May 7, 1992

FINAL  
ENVIRONMENTAL IMPACT STATEMENT  
FOR THE  
STRATEGIC TARGET SYSTEM

*Volume I  
Responses to Comments and Changes to Draft EIS*

Figure 2-4. Strategic Target System launch vehicle comparison.

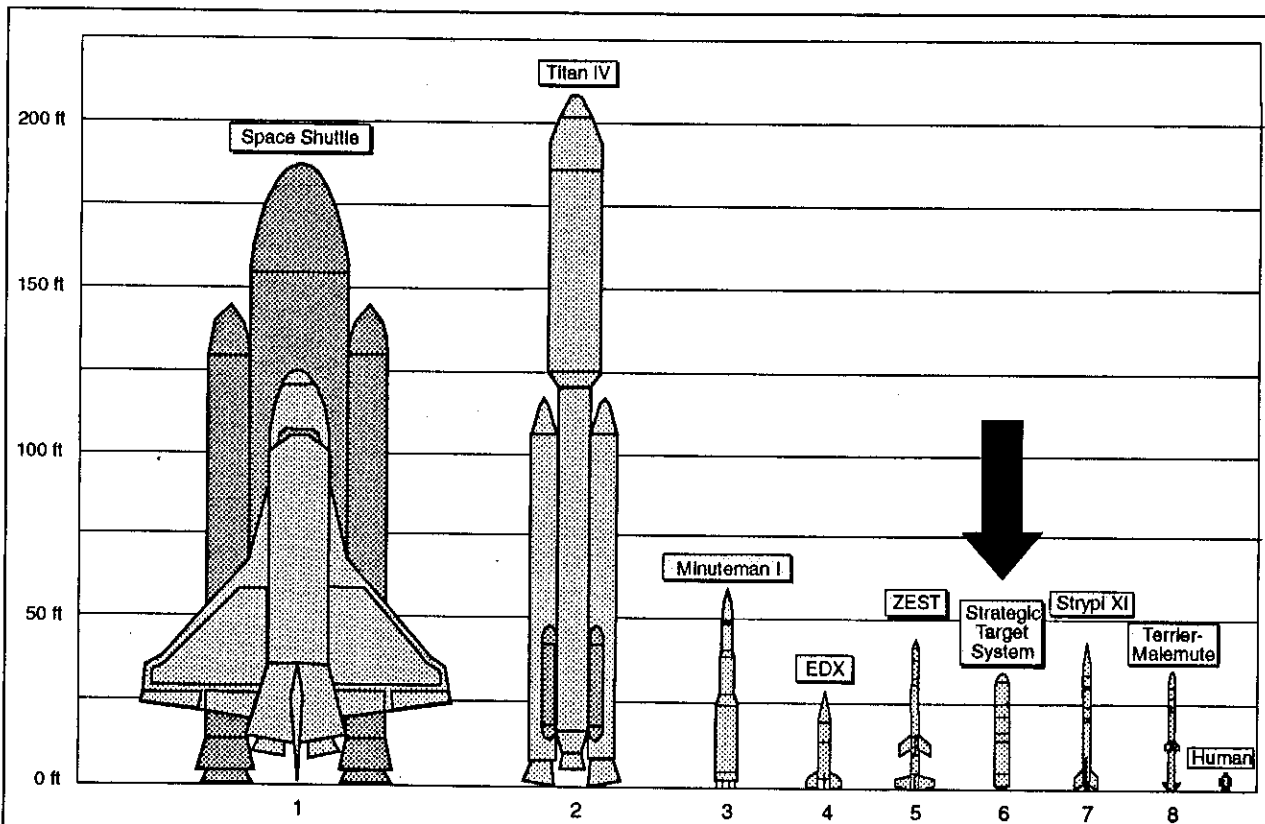
**Response to comment OR138-3:** See Chapter 2, Additions and Revisions to the Draft EIS, where Figure 2-4 has been revised to show the ground hazard areas for each of the other rockets.

**Response to comment WR231-6:** Figure 2-4 of the Draft EIS has been revised to reflect ground hazard areas for the comparison rockets.

**Page 2-5, Figure 2-4:** Figure has been revised as shown on page 2-2.

Figure 2-13. Strategic Target System ground hazard area.

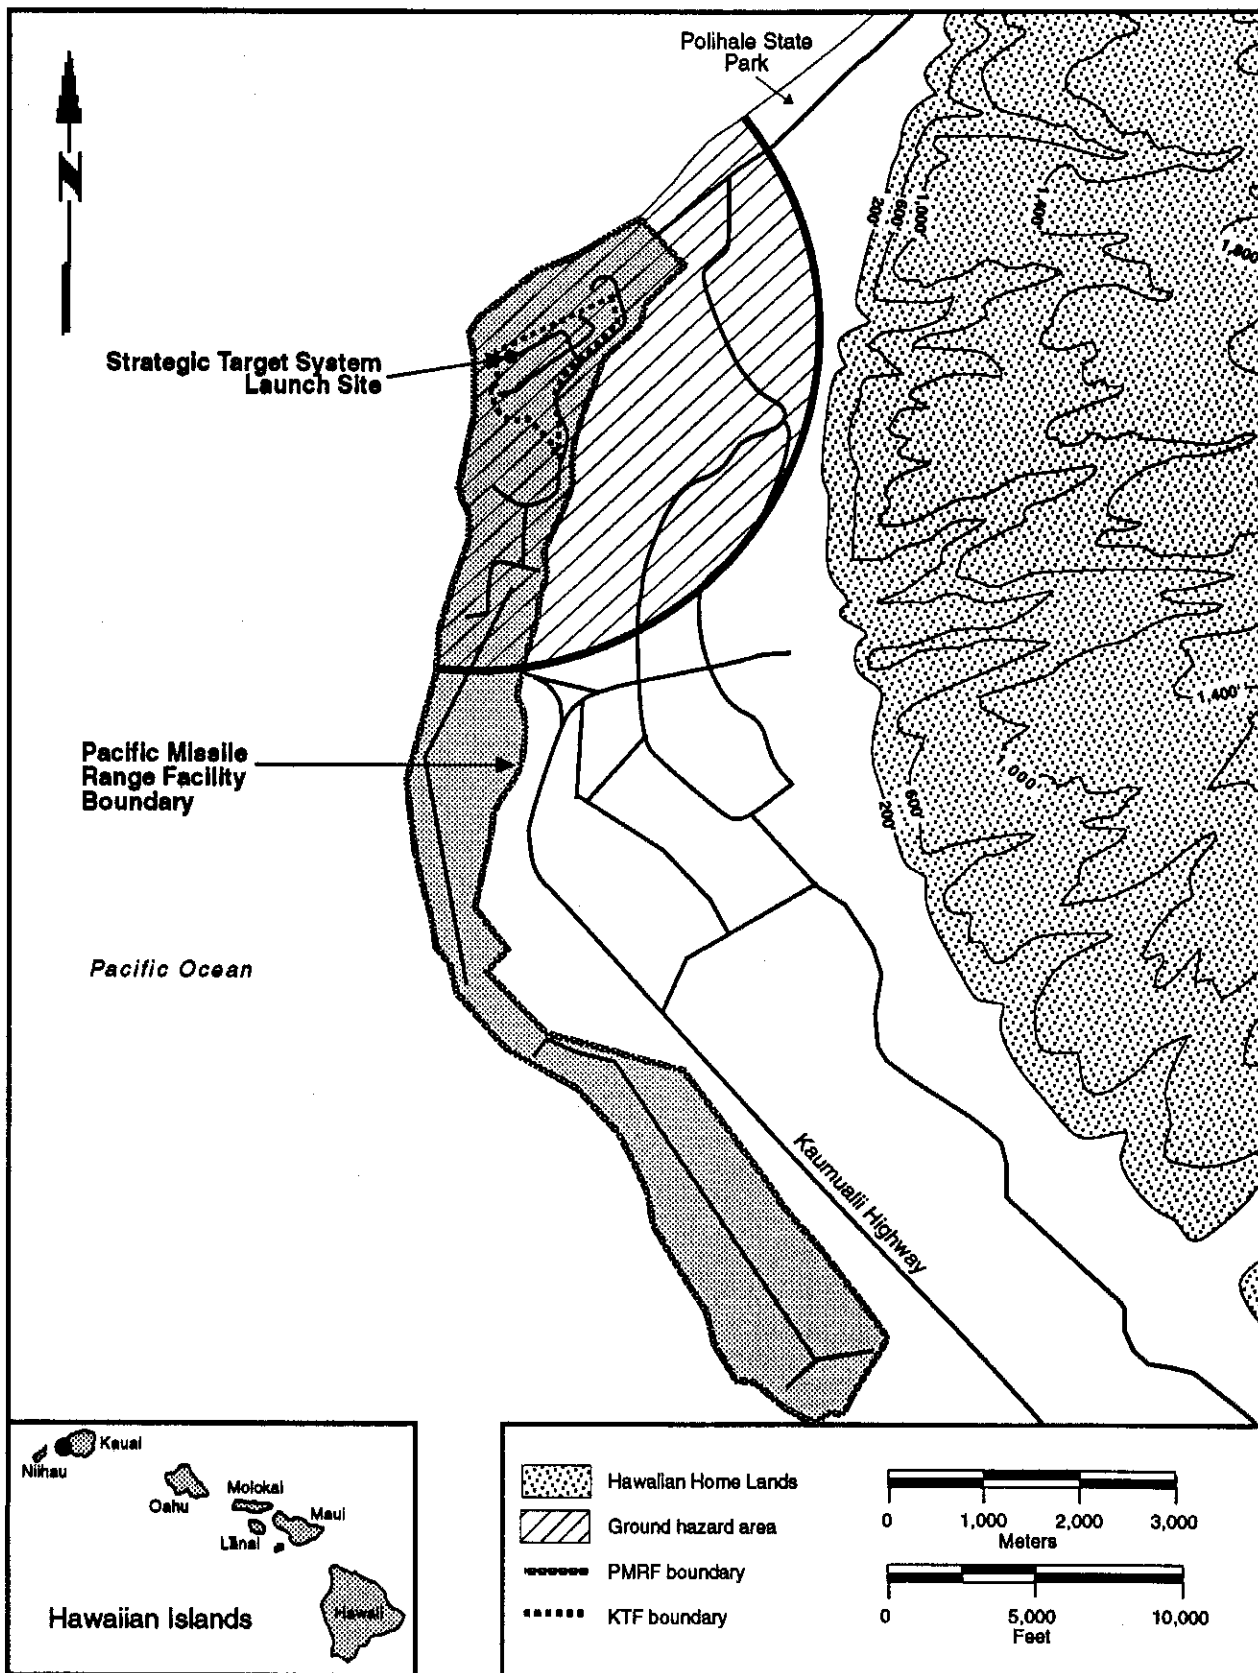
**Response to comment WR67-1:** As shown on page 2-23, Figure 2-13 of the Draft EIS, the Strategic Target System activities, including the ground hazard area do not affect lands designated as Hawaiian Home Lands. See also response to comment OR7-1.

**Page 2-23, Figure 2-13: Figure has been revised as shown on page 2-4.**

Figure 4-1A. Pacific Missile Range Facility recreational areas.

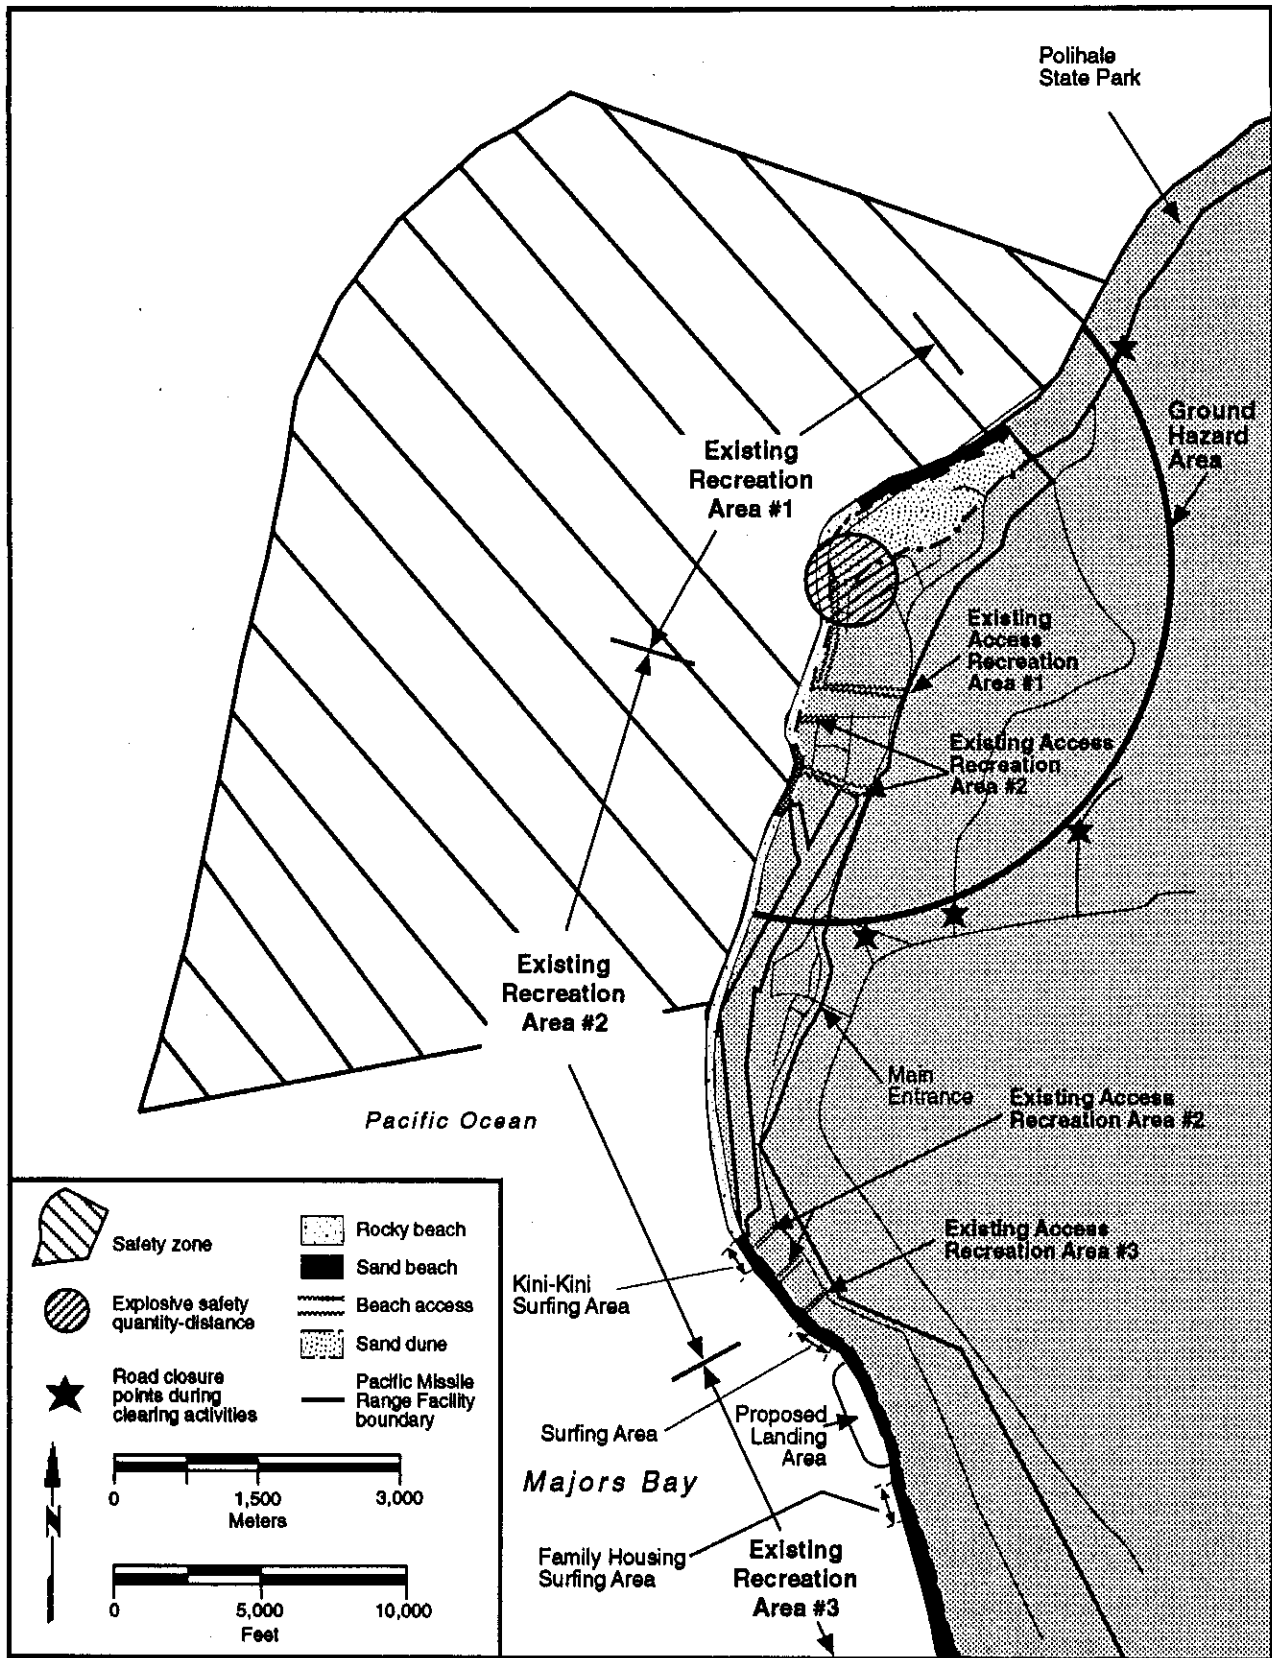
**Response to comment OR1-6:** The portion of the coastline affected by the closure (explosive safety quantity-distance) imposed when the vehicle is on the launch pad is a small portion of Recreation Area #1 (see Draft EIS, Figures 3-9 and 4-1) on PMRF. While, on the whole, the beaches on PMRF are popular portions of the coastline, the small (~ 0.5 mile) stretch of beach affected by the 56-day-per-year closure has a history of more limited use. During a recent 3-year period, 11% of the people who signed in at the gate to use the beaches at PMRF said their destination was Recreation Area #1. Of these, 43% said they were going there to fish.

A figure has been added to clarify the exact portion of Recreation Area #1 that would be closed for 56 days a year and its relationship to other beach areas of PMRF. This figure can be found in Chapter 2 of this volume.
